ATTACHMENT B

PROPOSED AMENDMENTS TO THE  
LICENSE/TECHNICAL SPECIFICATIONS

### HISTORY OF LASALLE UNIT 1 AND 2 MAIN STEAM TUNNEL LEAK DETECTION ISOLATIONS

### BASIS FOR DELETION OF MAIN STEAM LINE TUNNEL TEMPERATURE HIGH PRIMARY CONTAINMENT ISOLATION TRIP FUNCTION

Figure 2

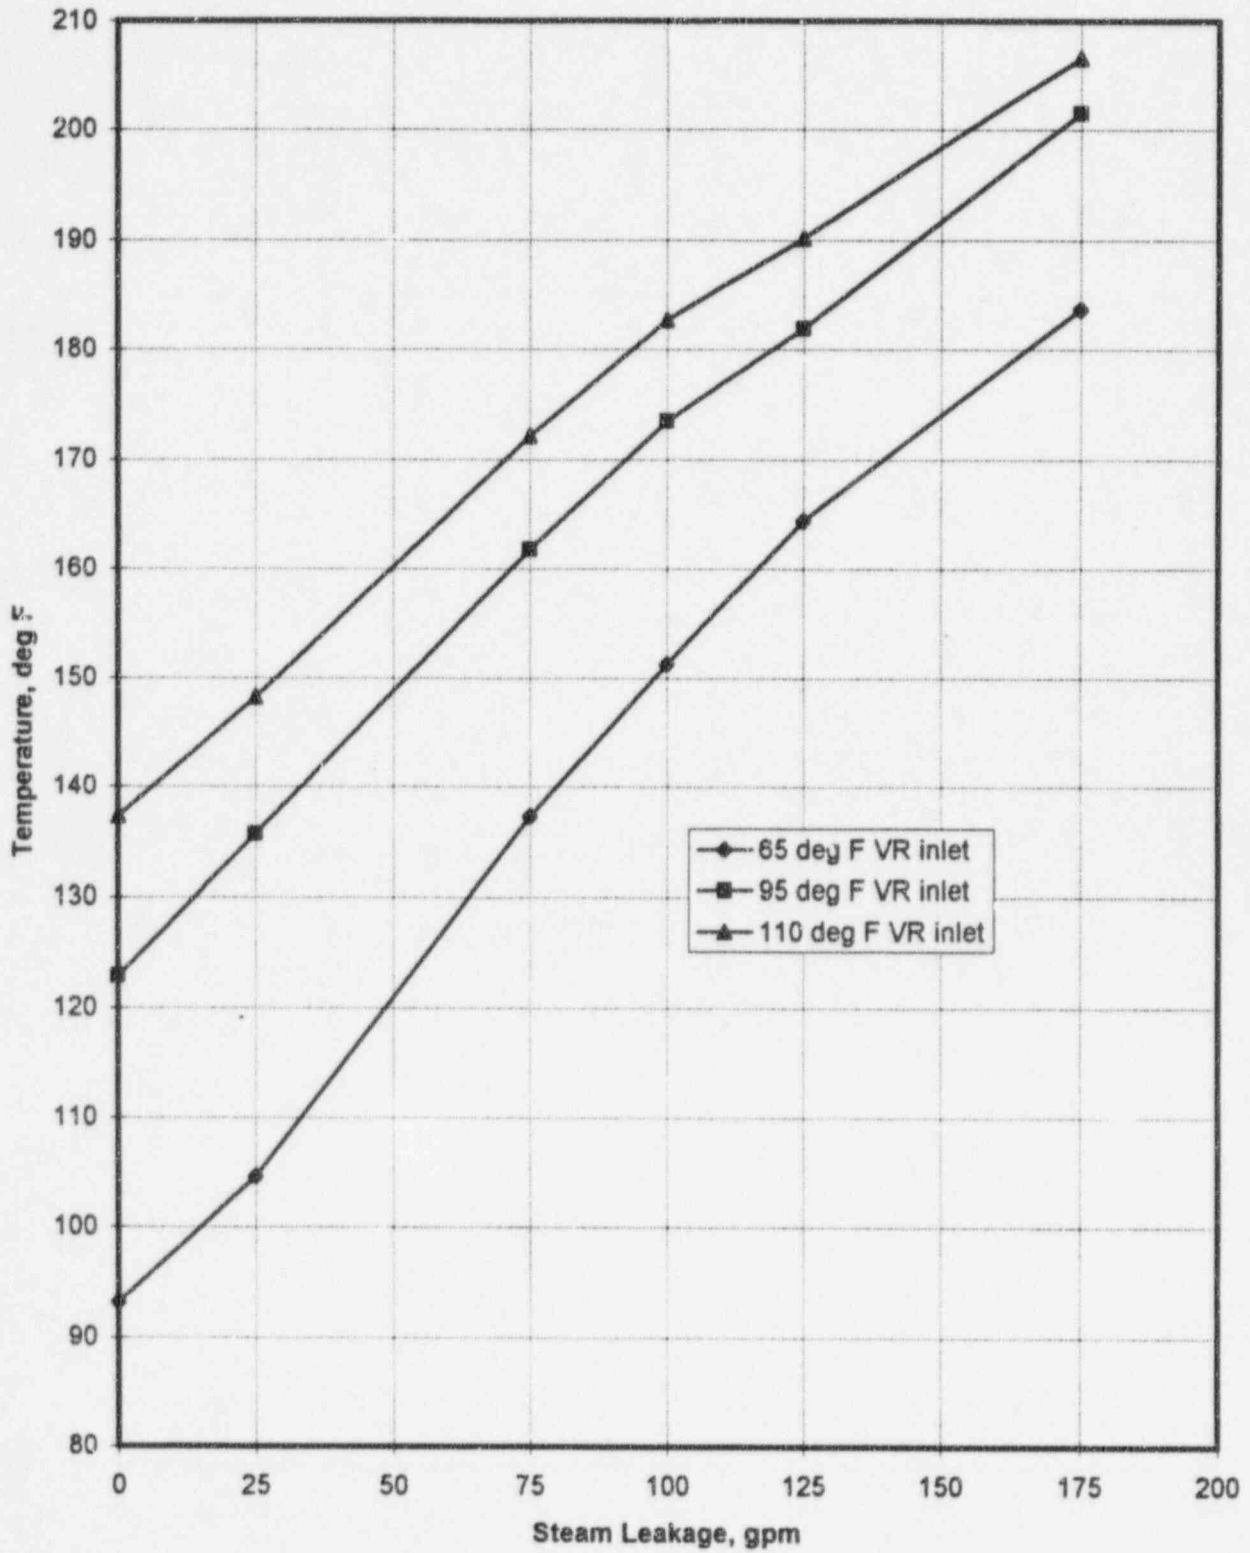
The data (see Figure 2 attached) indicates that with a 65 °F VR inlet temperature and a 125 gpm leak in the lower MST, the upper MST temperature would reach a value of approximately 164 °F. Using a leak detection setpoint for the temperature high of 164 °F would still result in the requirement to quickly bypass the isolation logic for a loss of VR in order to avoid the main steam isolation. The required response of bypassing the logic becomes even more critical on hotter days. In order to eliminate the need to bypass the leak detection logic on a loss of VR, a temperature high setpoint of ~200 °F would be required. The crack leakage required to generate a 200 °F temperature in the upper MST with VR in operation with a 65 °F inlet air temperature would be several hundred gpm. Therefore, leak detection isolation based on Main Steam Line Tunnel Temperature High would not allow operation without the potential for spurious trips.

Figure 3

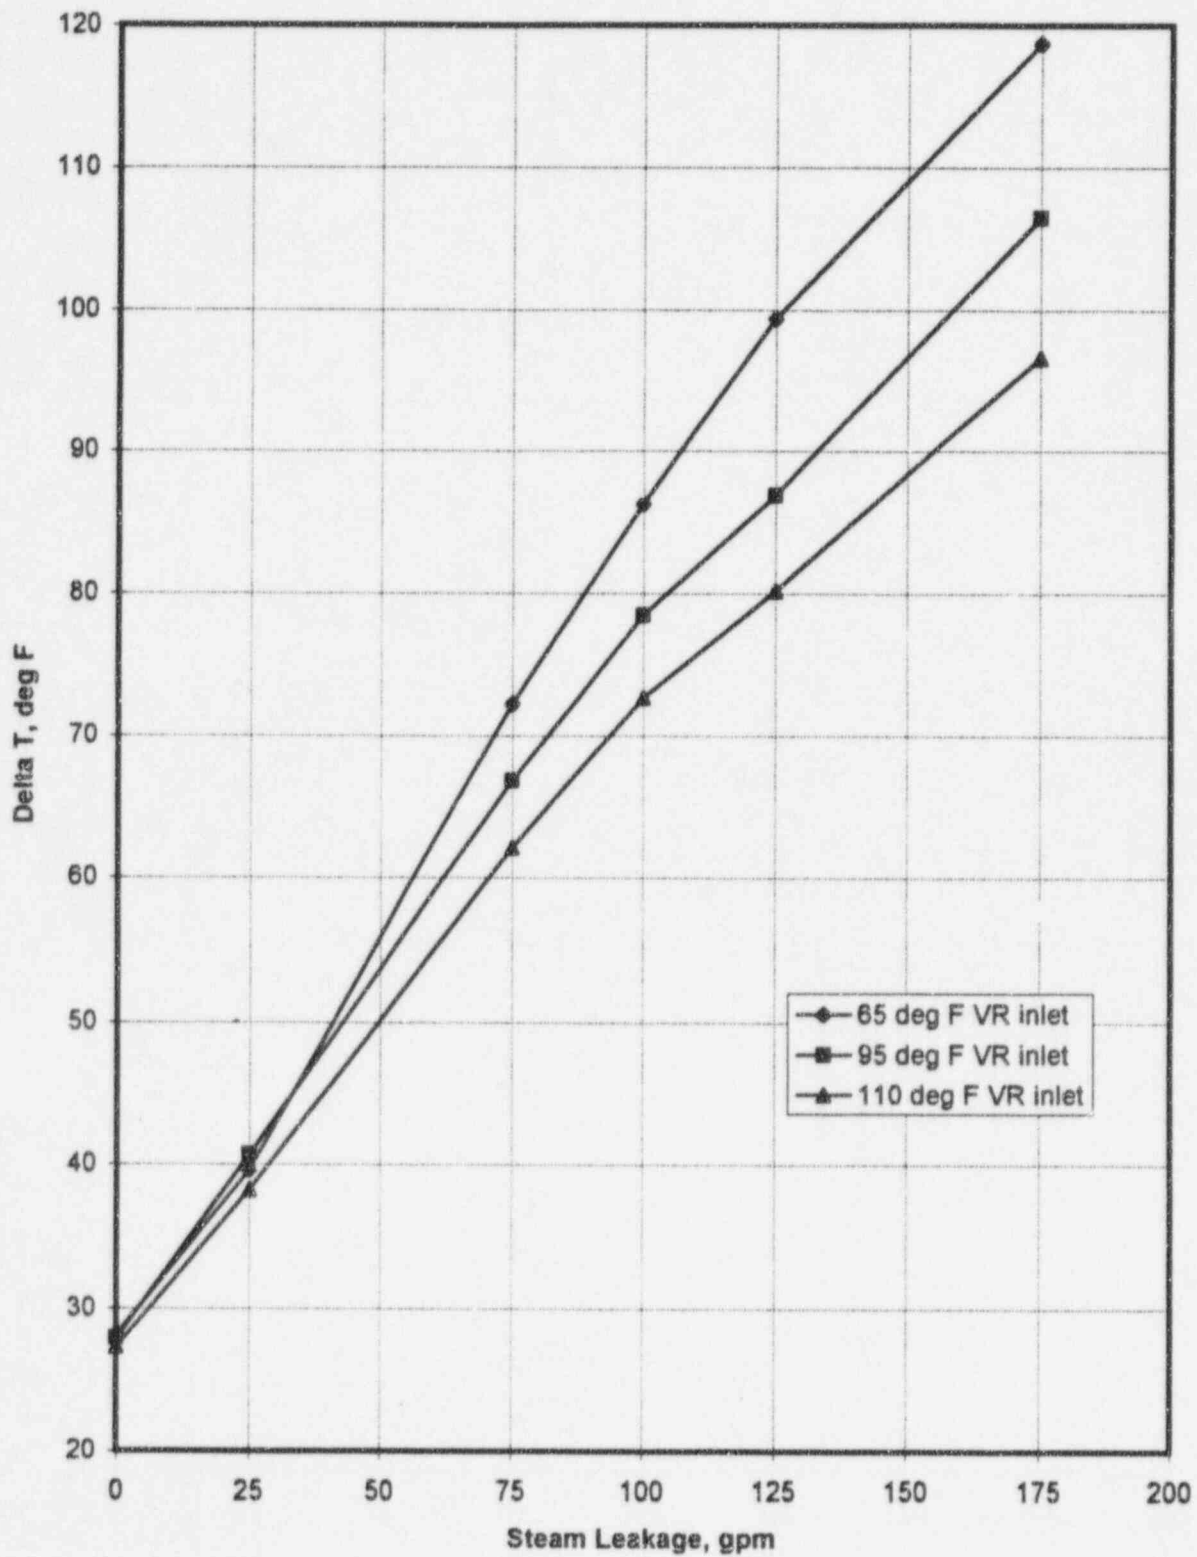
The data (see Figure 3, attached) indicates that with a 110 °F VR inlet temperature and a 100 gpm leak in the lower MST, the upper MST differential temperature would reach a value of 72.5 °F. It is estimated that over 99% of the year the VR inlet temperature will be less than or equal to 100 °F. With the VR inlet temperature less than 110 °F, the setpoint will actually be isolating the main steam lines on a leak of less than 100 gpm.
